# PCN-20210621 TEB0911-04 eMMC Change and Product Update

| Company    | Trenz Electronic GmbH                     |
|------------|-------------------------------------------|
| PCN Number | PCN-20210621                              |
| Subject    | BOM change                                |

This change affects all Trenz Electronic TEB0911 boards of revision 04: TEB0911-04

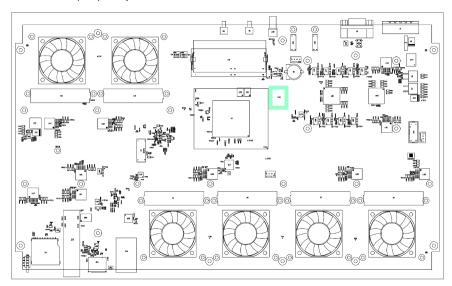
Locate eMMC (U26) on top side of PCB:

## #1 Change eMMC (U26) from IS21ES08G-JCLI to SDINBDG4-8G-XI2
